February 9th, 2026

Mr. Alan Sielaff
Assistant Town Planner
Town of Fraser
PO Box 370
Fraser, CO 80442

On behalf of Grand Park Development, Terracina Design is submitting a revised Final Plat & FPDP for Grand Park West Mountain Filing No. 1 Planning area 10W.1 & 11W to address the comments dated January 26, 2026. See responses below.

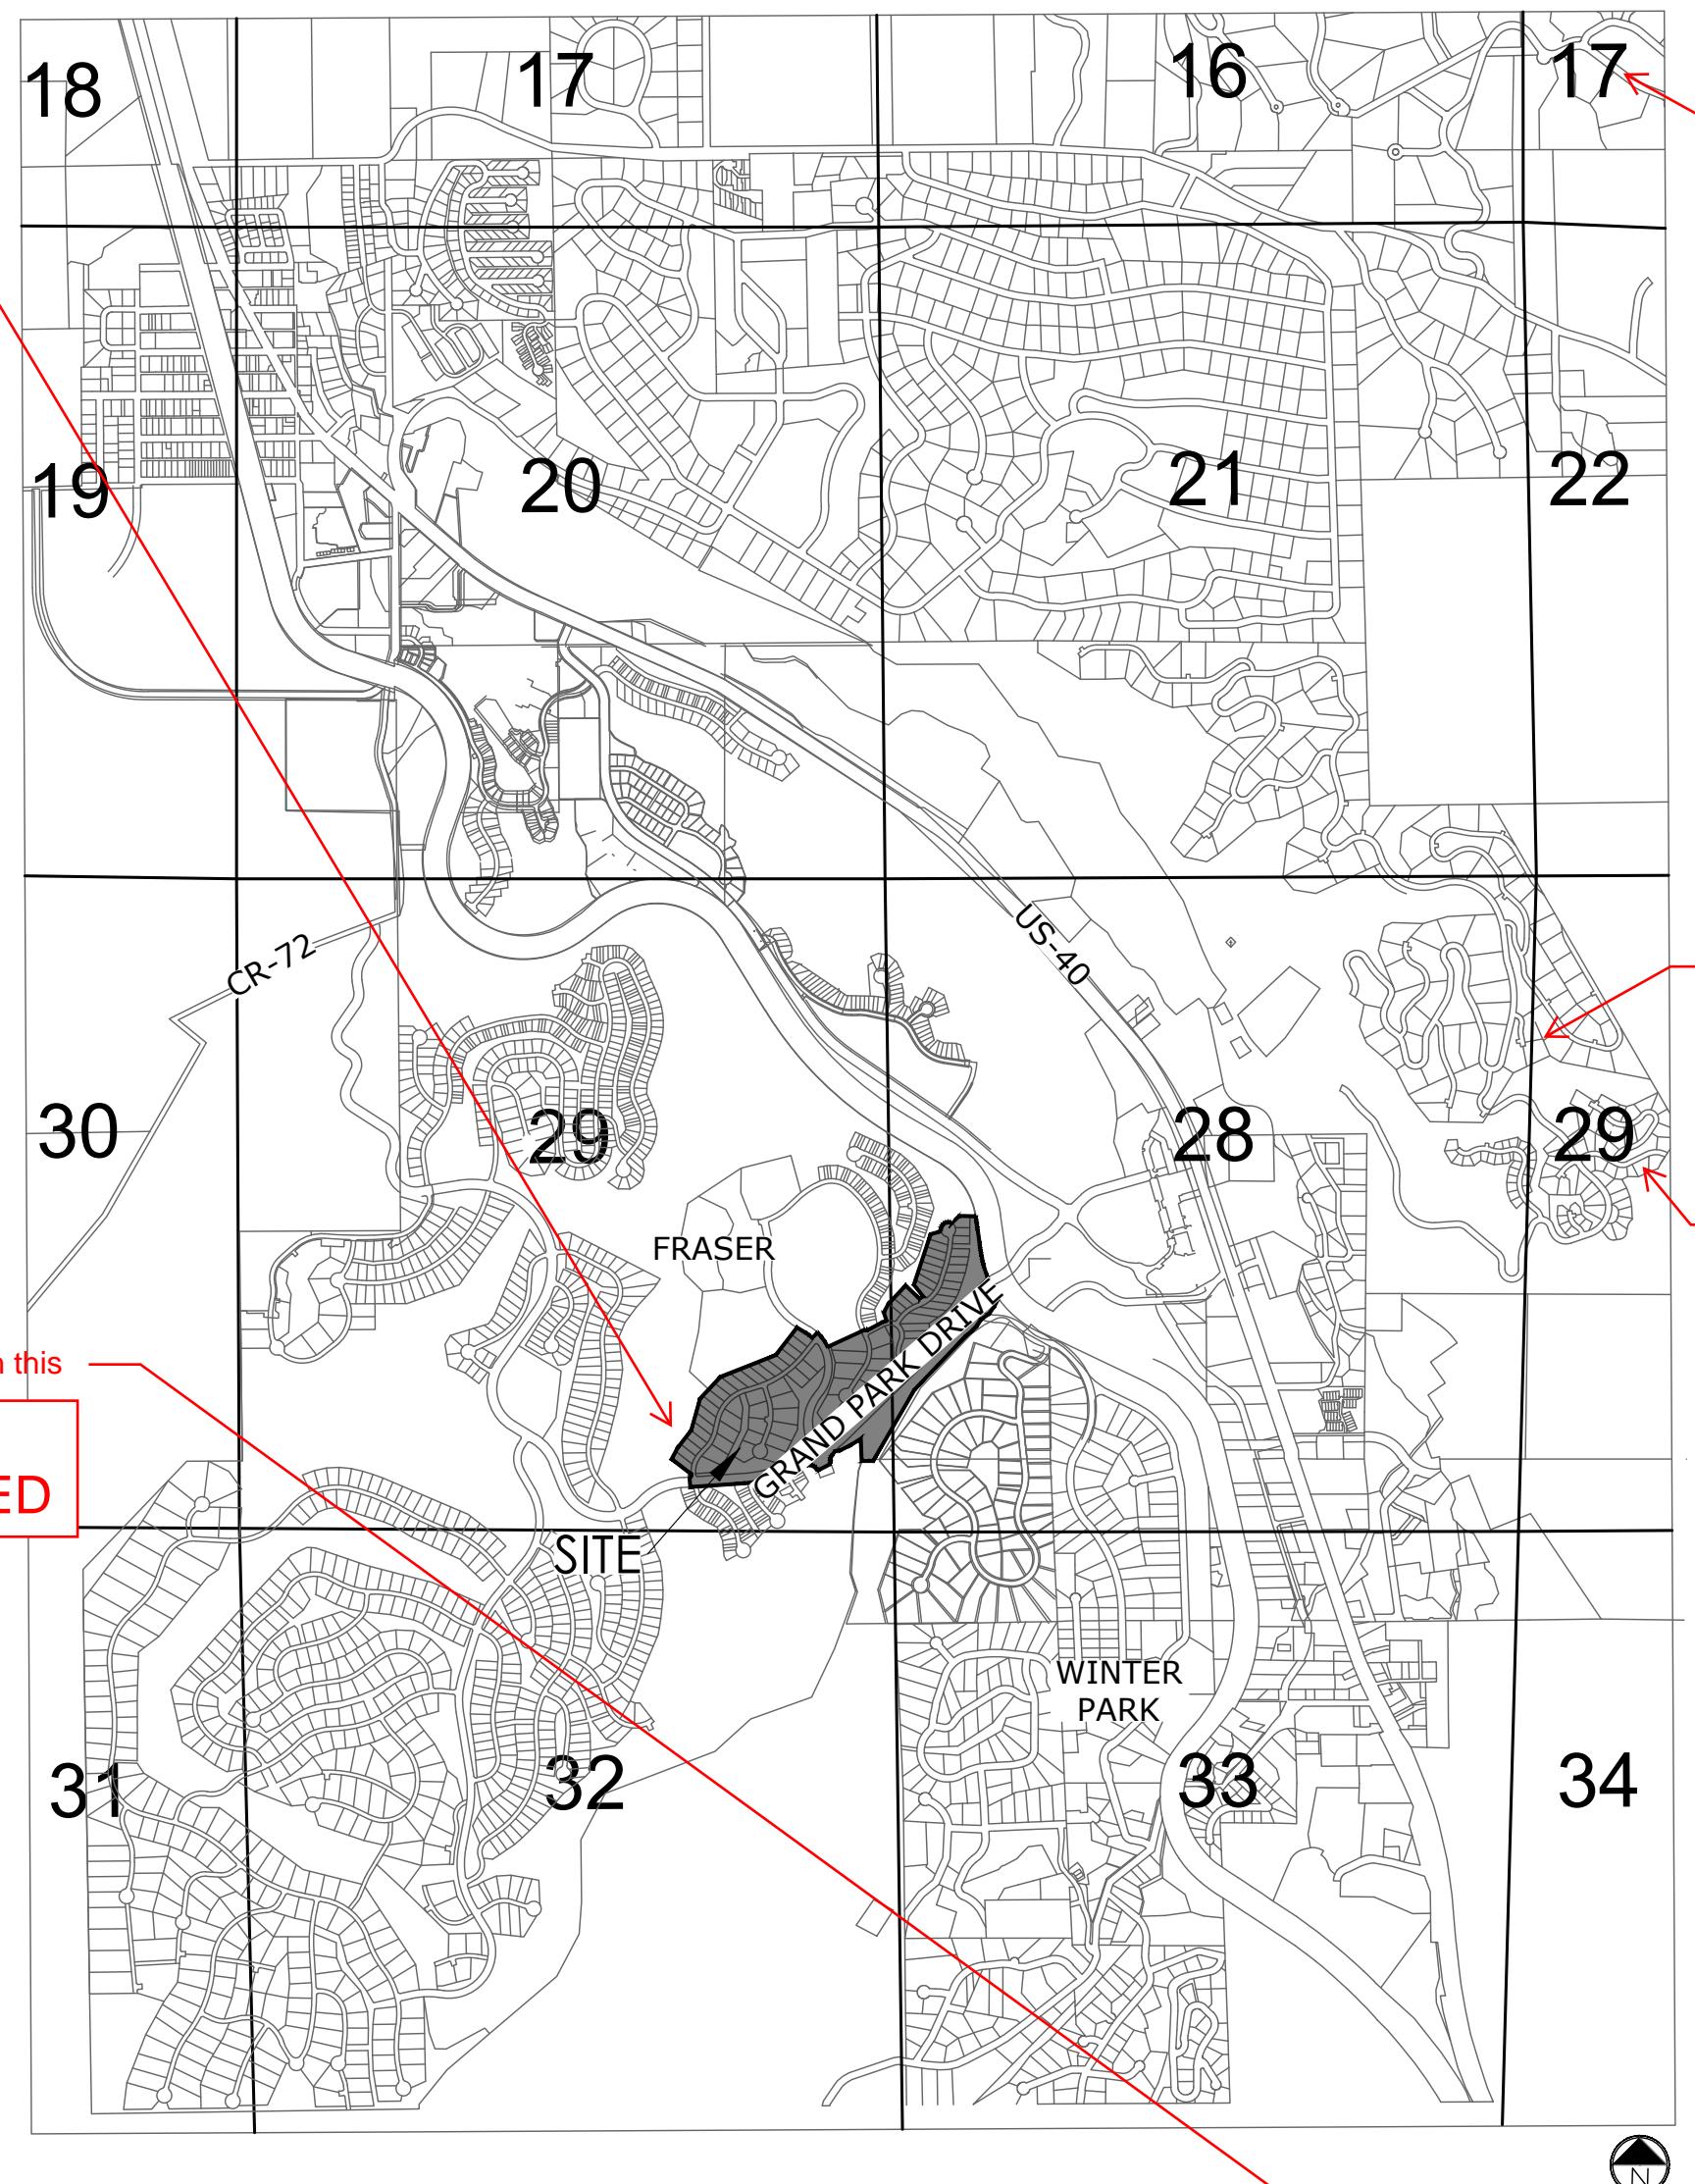
This doesn't appear
to match this,
please verify

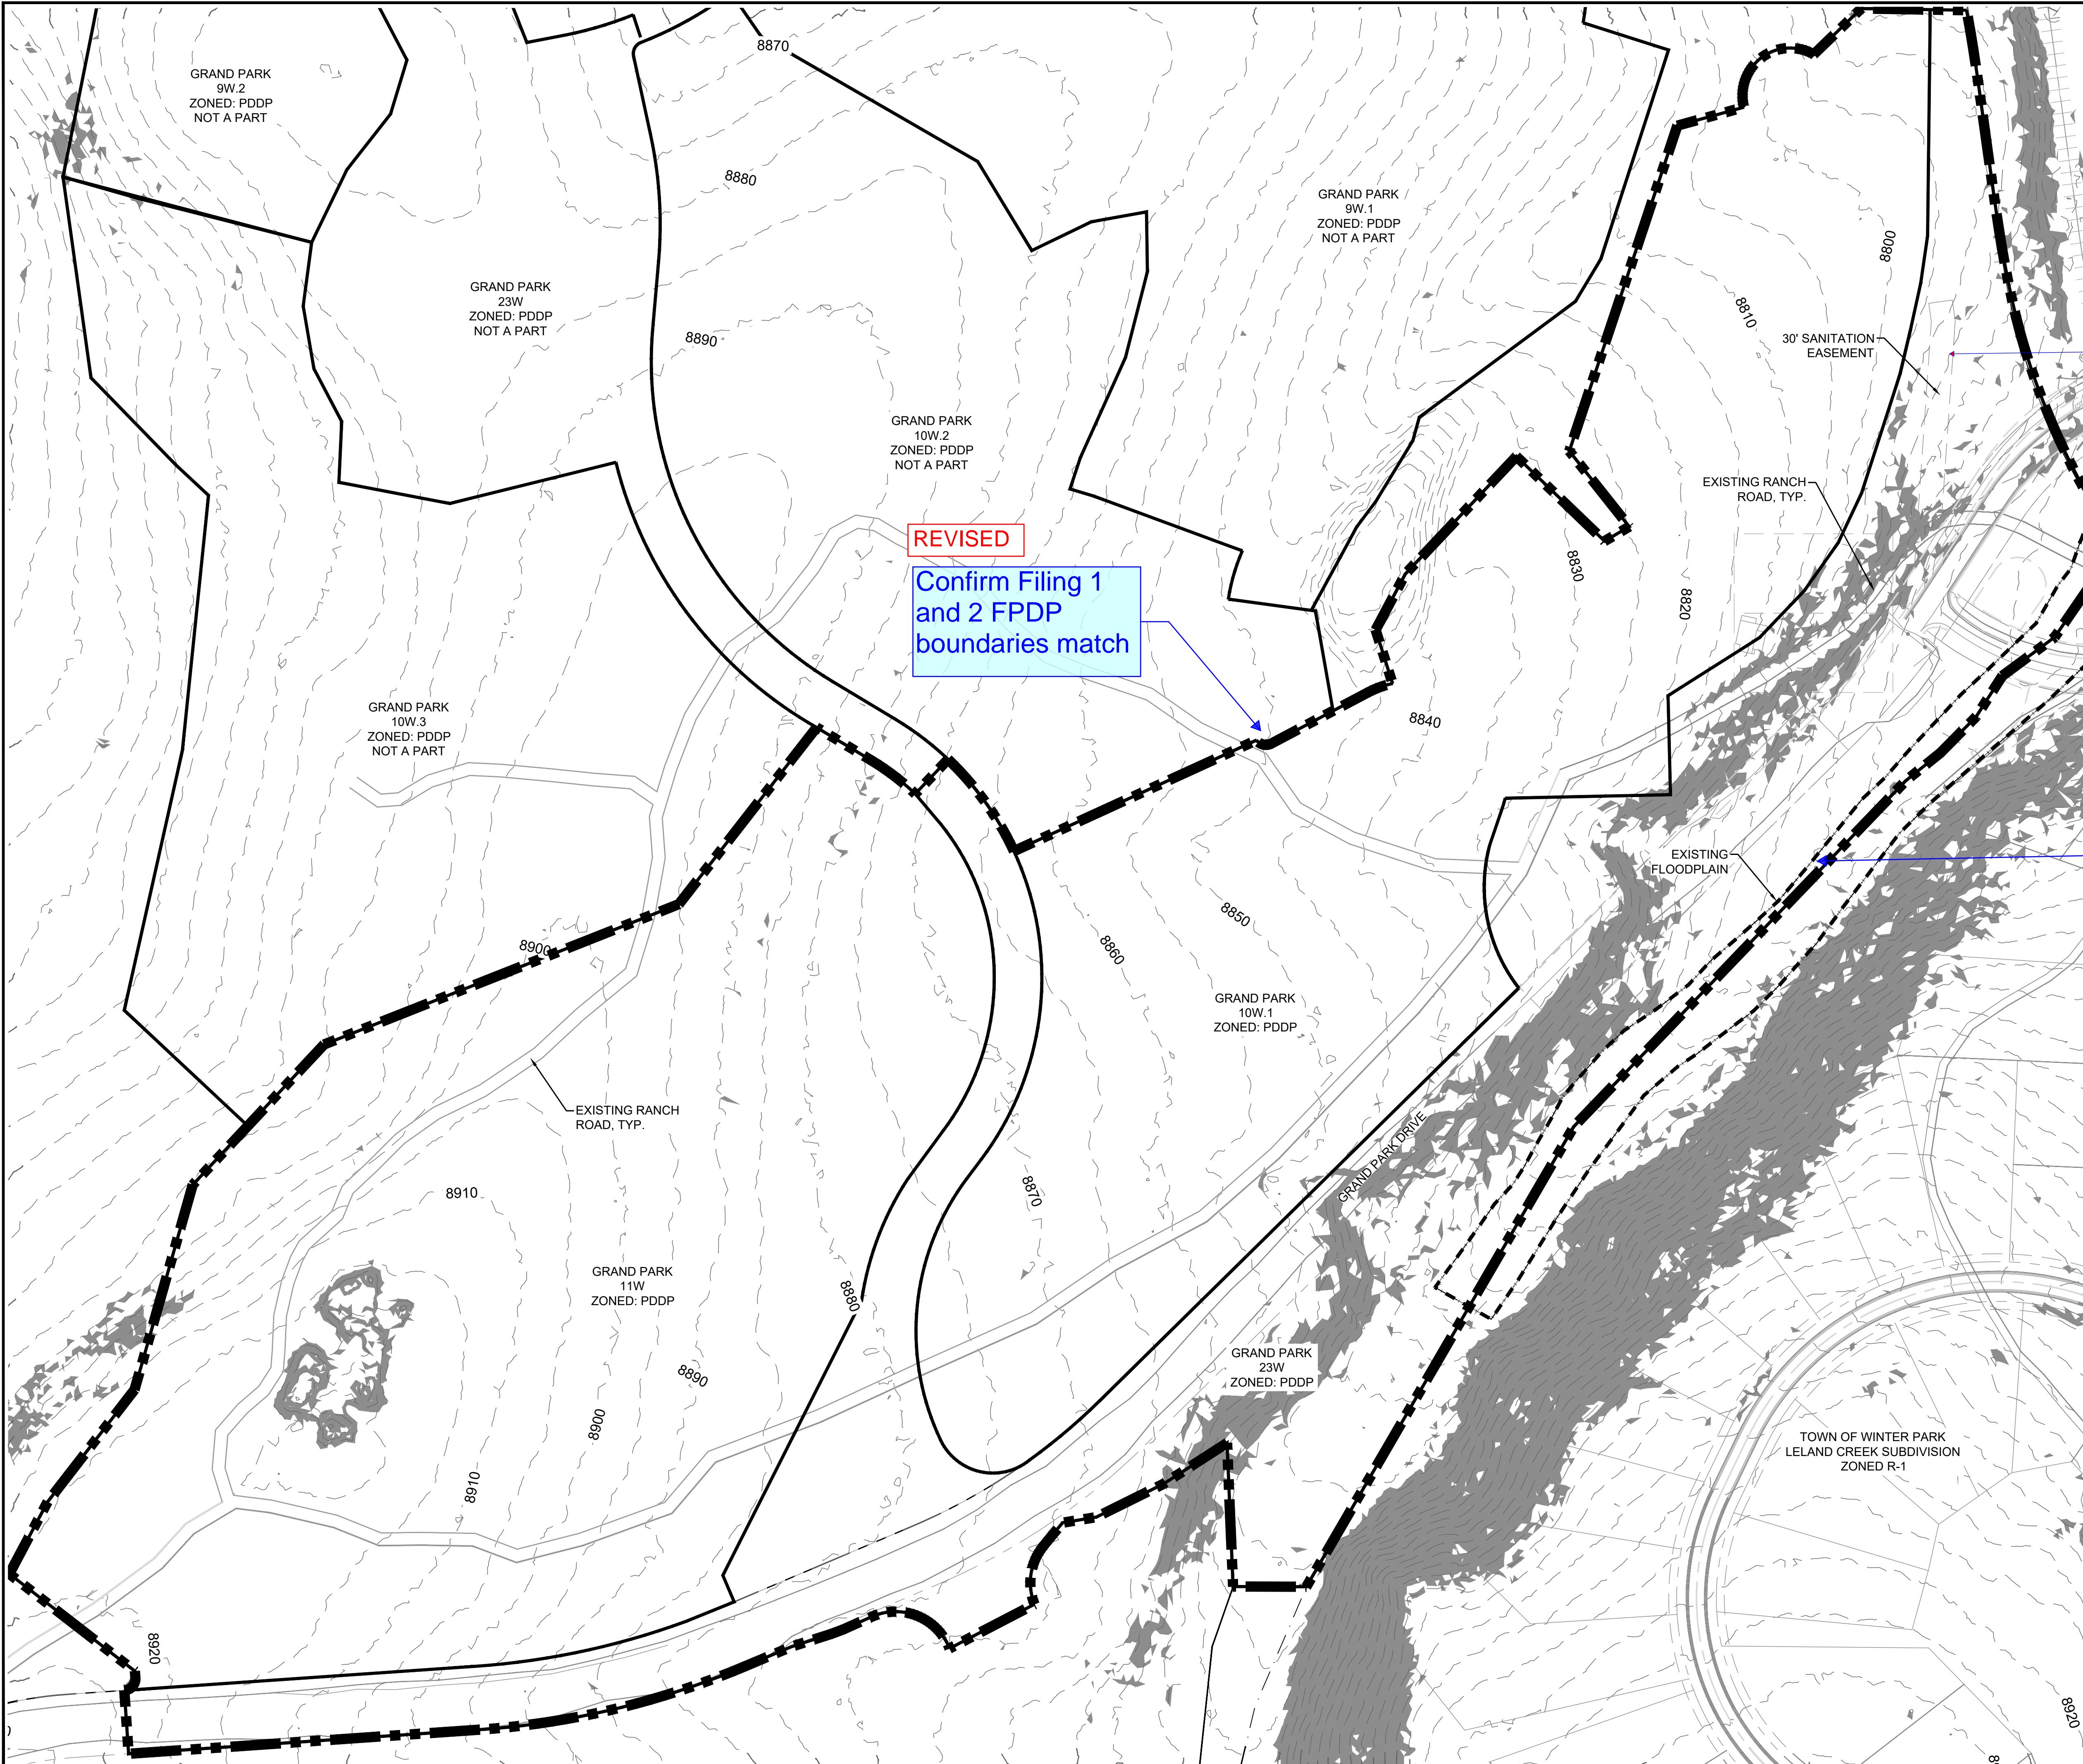
NOTES ADDED BACK IN

Notes 12 and 13 from previous submittal have been removed:
12. Final engineering documents, construction drawings and site specific geotechnical report shall be submitted and approved prior to building permit issuance
13. All light fixtures shall be in compliance with the Town of Fraser Municipal Code Section 14-5-30 and 19-4-195 which regulate exterior lighting and require dark sky compliance

SECTION LINES REMOVED
BECAUSE NOT REQUIRED

LAND USE PLAN
DECEMBER 18, 2025
SHEET 3

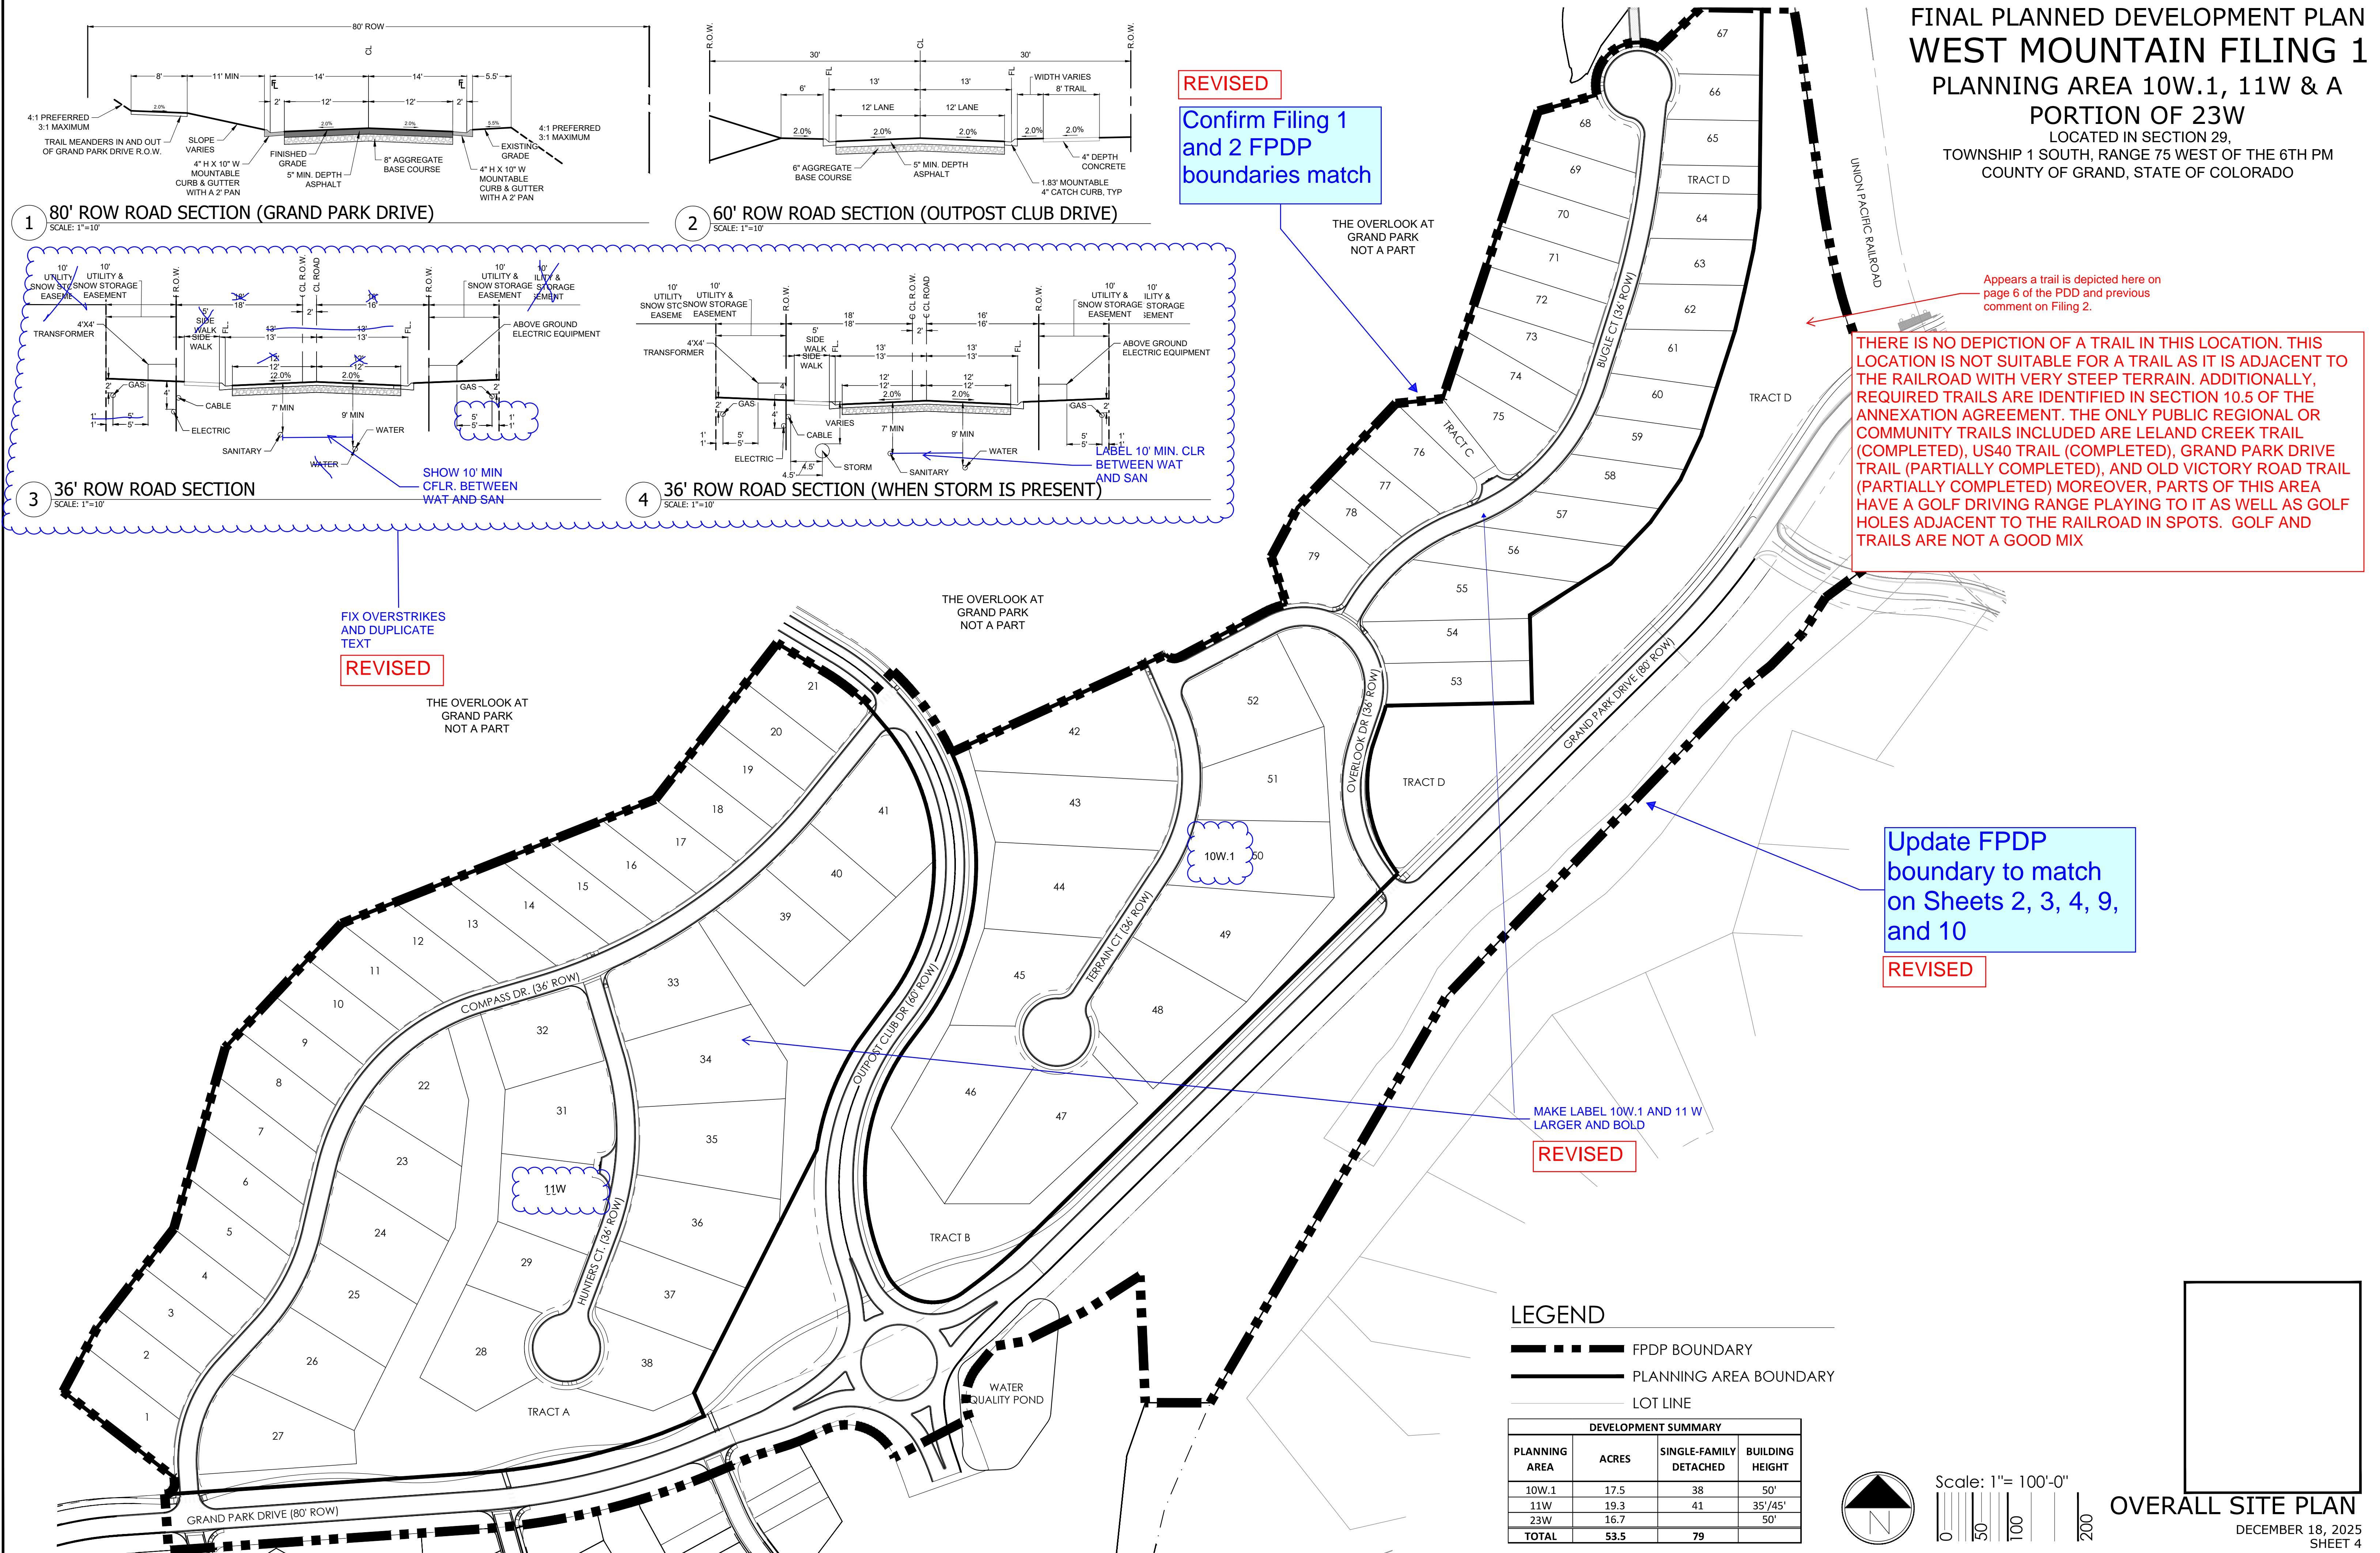
Confirm Filing 1
and 2 FPDP
boundaries match

Update FPDP
boundary to match
on Sheets 2, 3, 4, 9,
and 10

REVISED

REVISED
